Comprehensive Development Plan Fitchburg Minerals Property

South of Lacy Road & East of Fitchrona Road
City of Fitchburg
Dane County, Wisconsin

RE:
Fitchburg Minerals
Comprehensive Development Plan
Response to Evaluation Comments

PLANNING STAFF REVIEW #1 DATED 04/05/21

PROPOSED ZONING PLAN

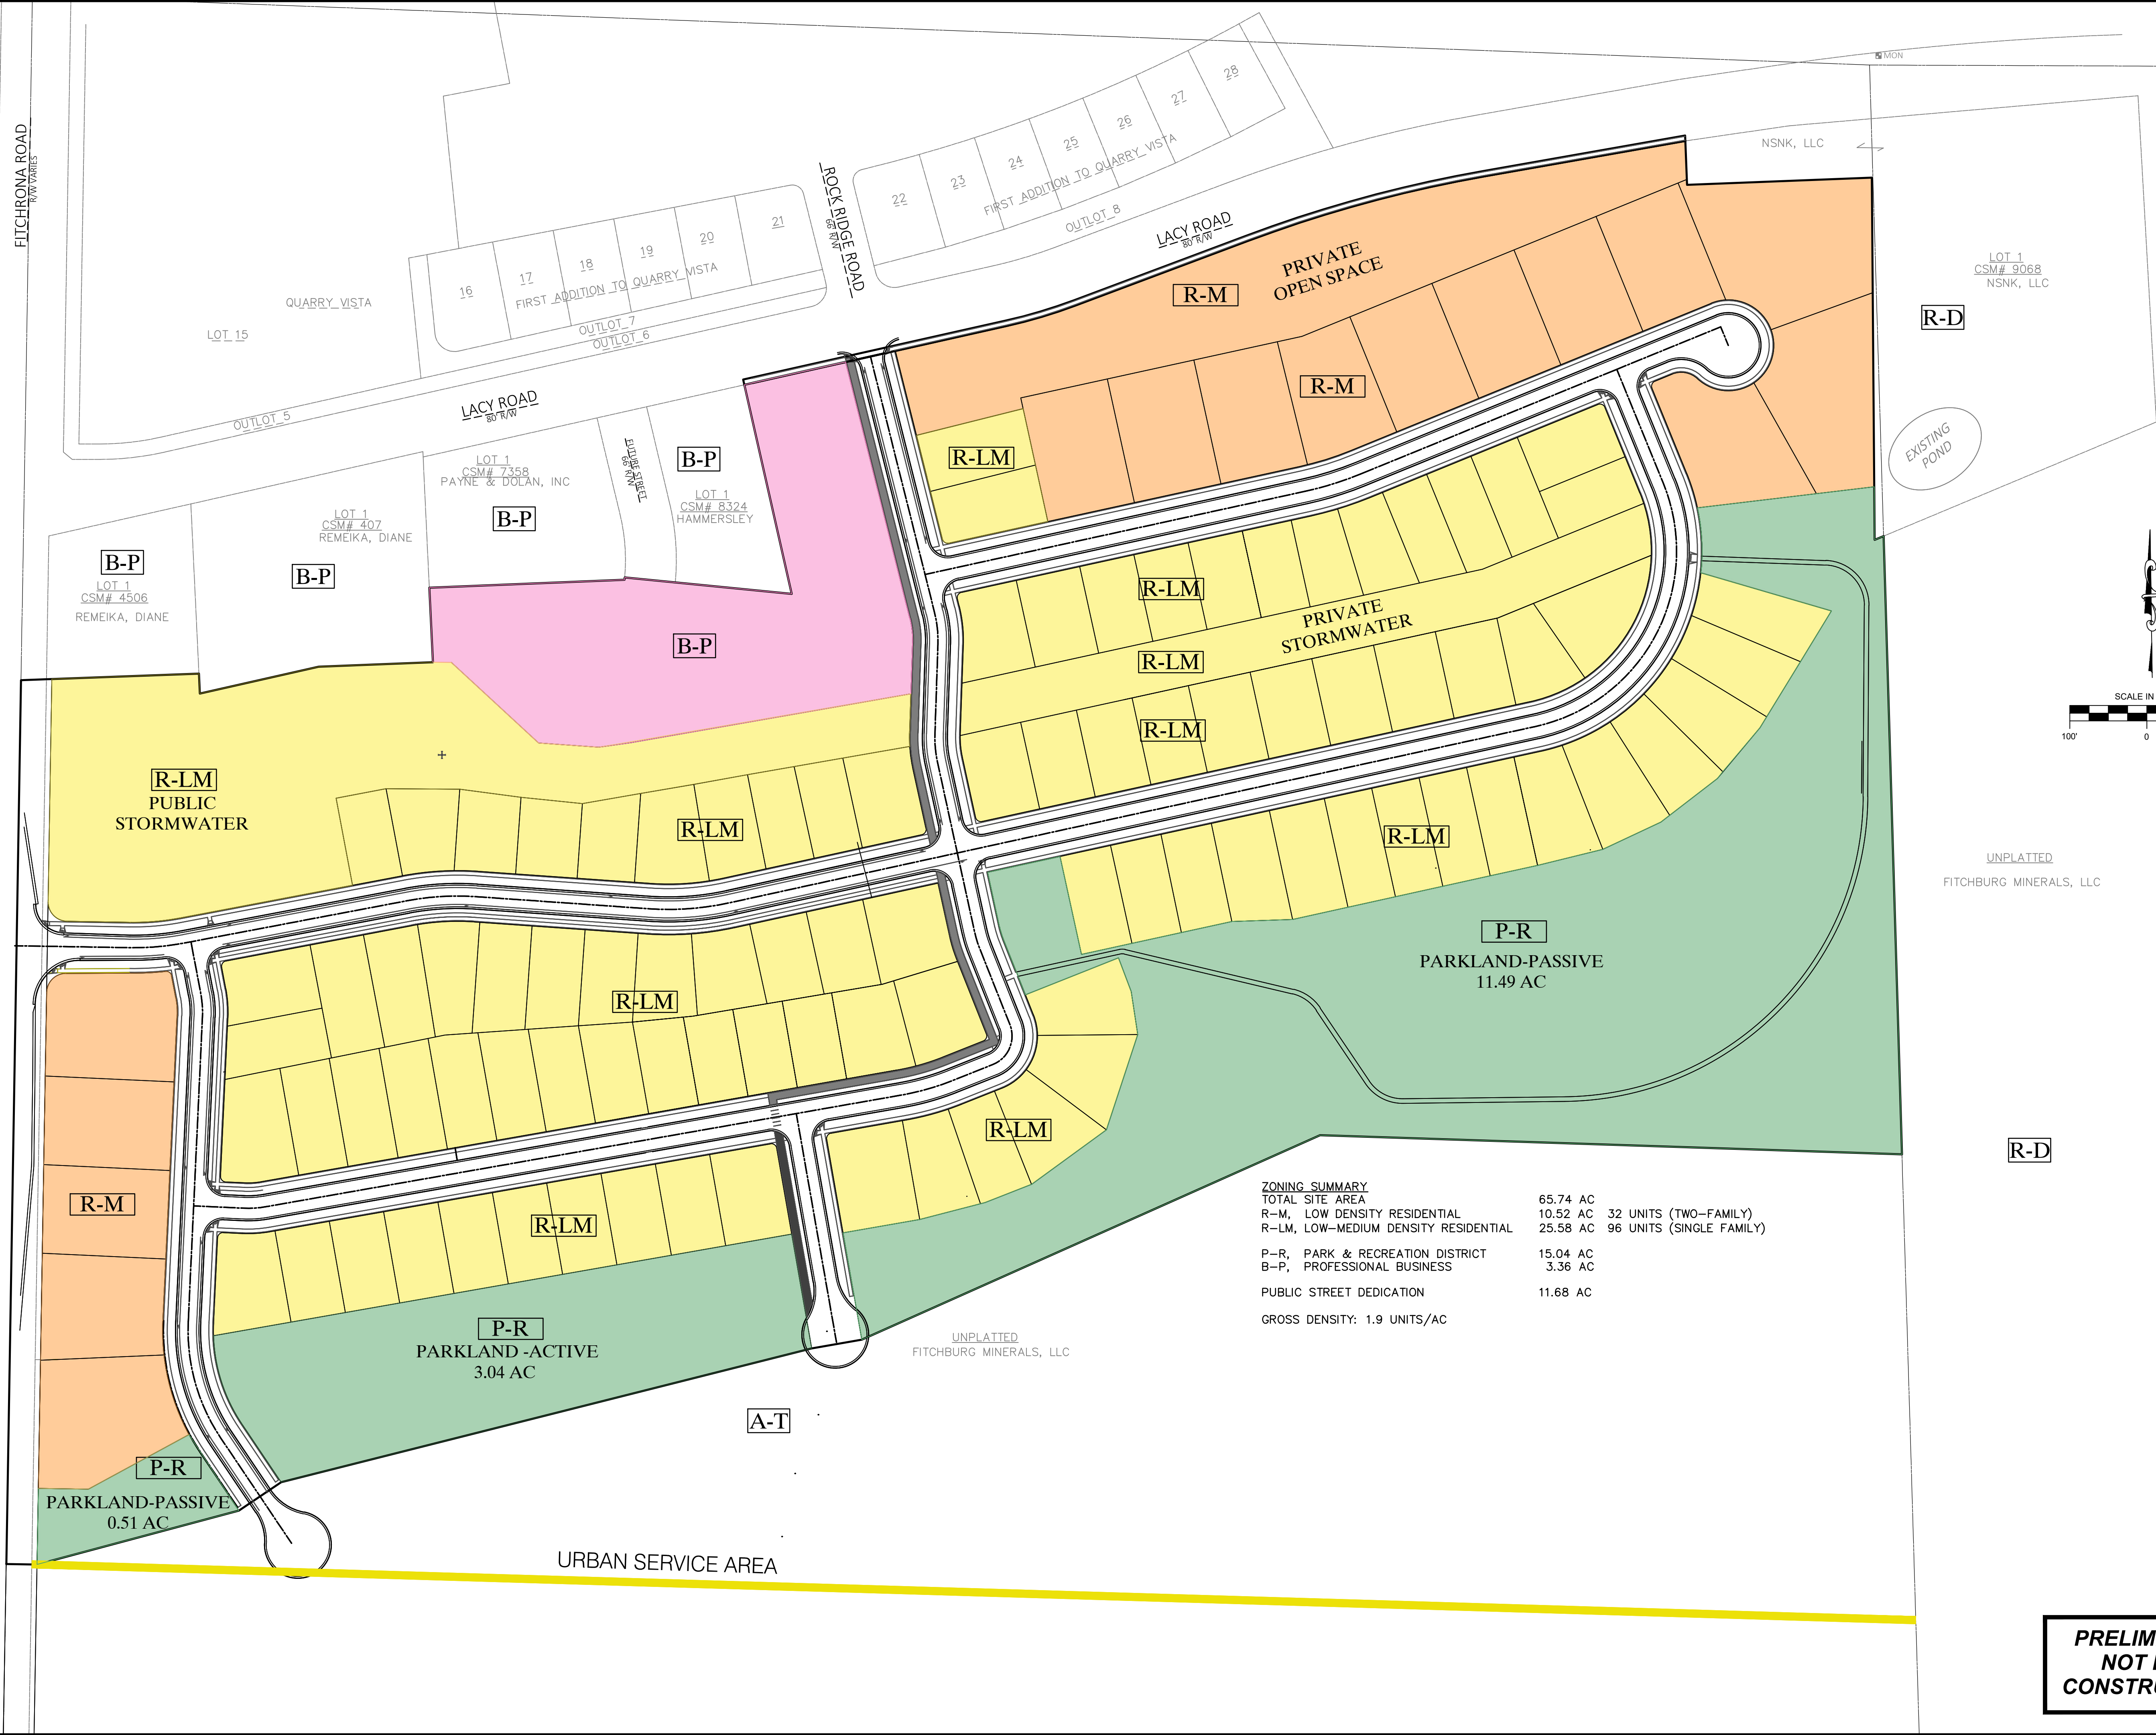
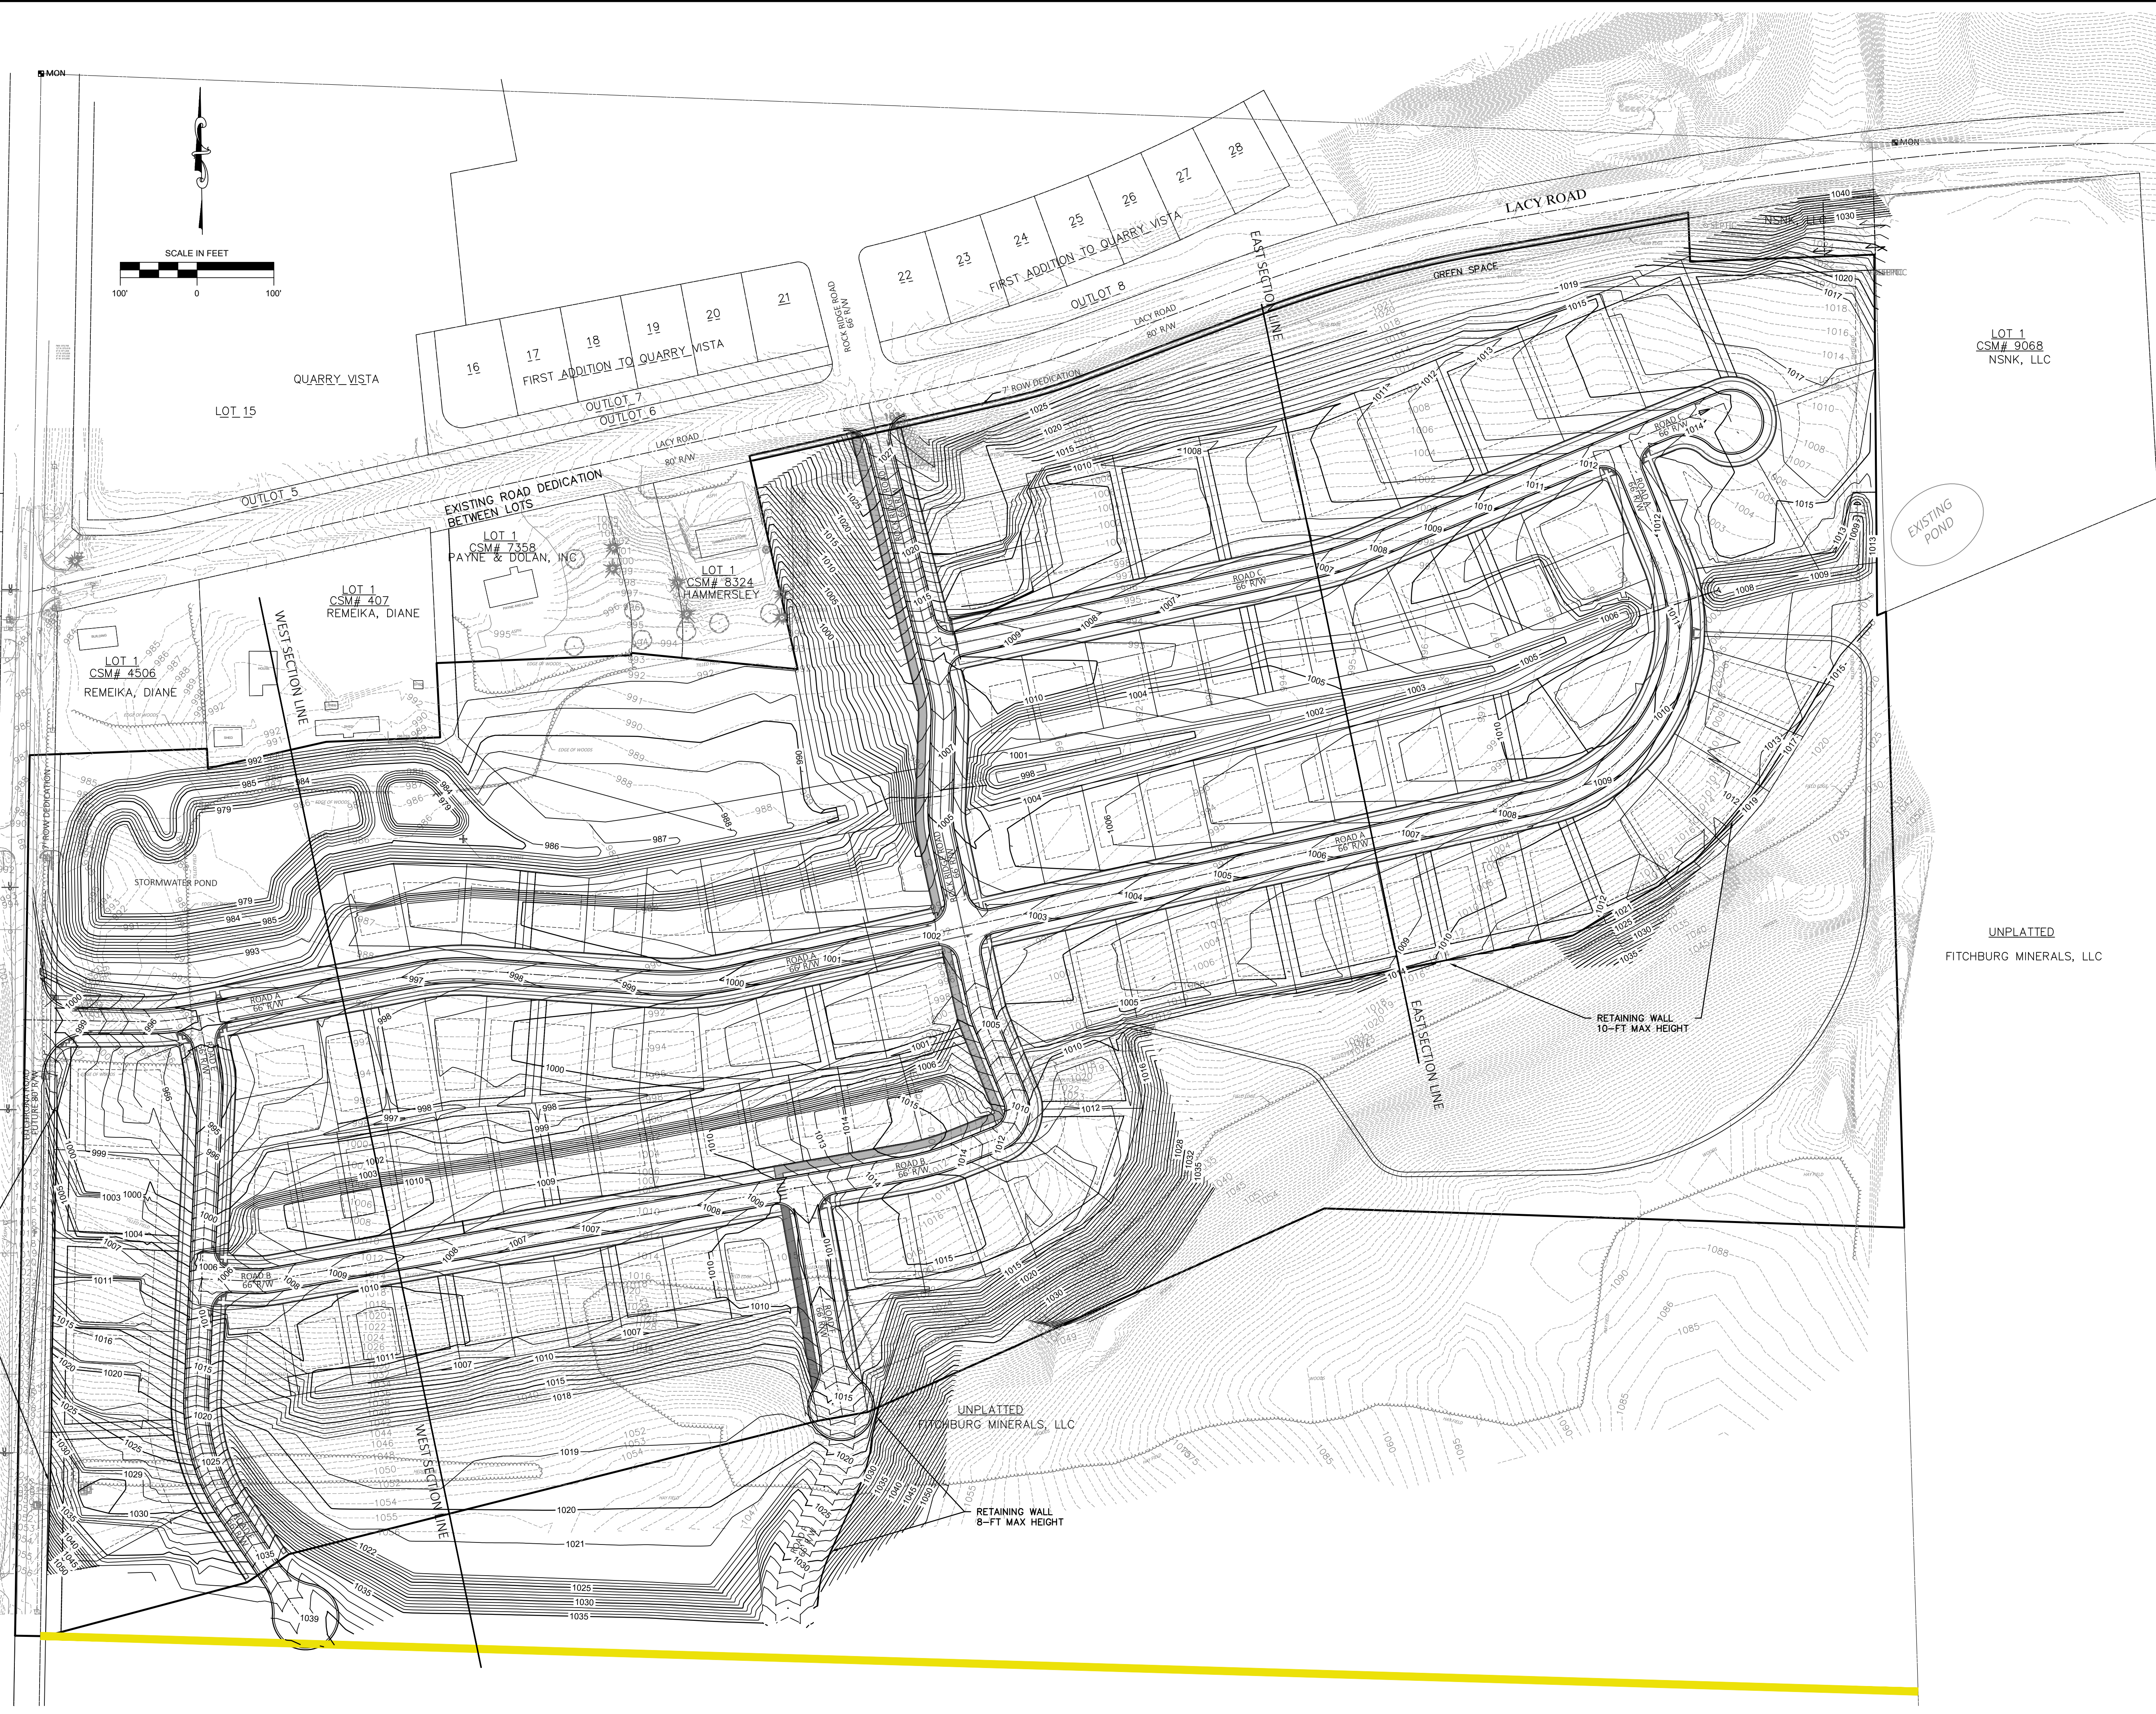
- The document should include the calculation for required parkland dedication.
 - The parkland dedication calculation has been added to the zoning exhibit as requested.

- a. The reference has been removed.
8. Will the development meet the required land dedication for parks? 2,900 sf required per unit in dedication, or pay a fee in-lieu of dedication. Please provide the calculation within the narrative. Park improvement fees will be due for each unit.

- a. Sufficient parklands will be dedicated with the development to satisfy the requirements. The computation has been added to the zoning exhibit.
9. The Lacy Road and Fitchrona Road street connections may be required at an earlier time than shown in the phasing plan. Review and discuss with Public Works.
